**UNITED STATES ENVIRONMENTAL
PROTECTION AGENCY
REGION IX
75 Hawthorne Street
San Francisco, CA 94105**

**STATE OF HAWAII
DEPARTMENT OF HEALTH
P. O. BOX 3378
HONOLULU, HI 96801-3378**

Re: Disapproval of Red Hill Administrative Order on Consent (“AOC”)- Attachment A Statement of Work (“SOW”) Deliverable for Sections 6 and 7 – Work Plan/ Scope of Work, Investigation and Remediation of Releases and Groundwater Protection and Evaluation, Red Hill Bulk Fuel Storage Facility (“Facility”), May 4, 2016

Figure 1. Hydrogeologic Scales for Basalt Vadose Zones

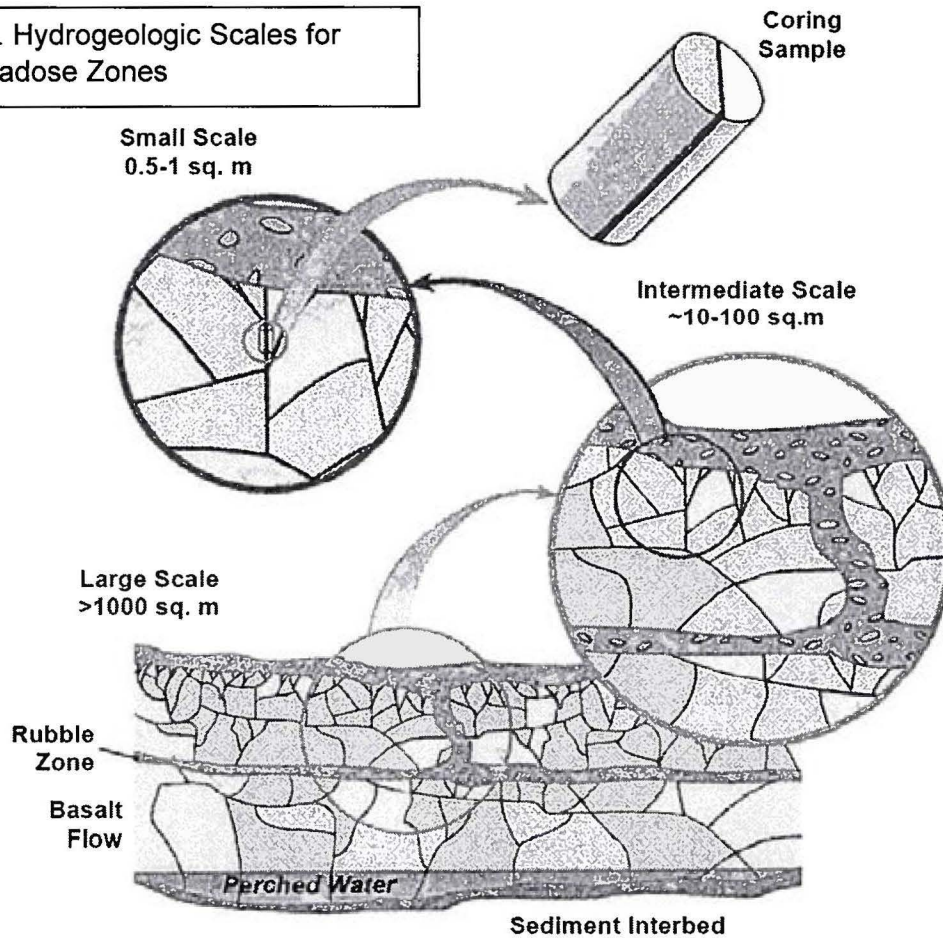
23. Section 3.7.4: Lines 10 through 14 are misleading and should be removed. The statements about low vertical permeability in the basalts presented here and in Sections 3.6.2.3 and 3.7.3 may well be true at small scales on the order of 1 meter², but such statements are readily contradicted by the fact that recharge occurs at rates between 10 and 25 inches per year in the Red Hill vicinity (see Oki, 2005 and Giambelluca 1983 for example). The authors appear to be solely focused on the micro-scale, whereas recharge and contaminant migration occur at the intermediate to large scales (Figure 1 below, which is adapted from Figure 3 in Fabysenko et al., 2000). If the massive components of a'a flows are so impermeable, how can

recharge occur at such a large rate over such a large area? If recharge is negligible
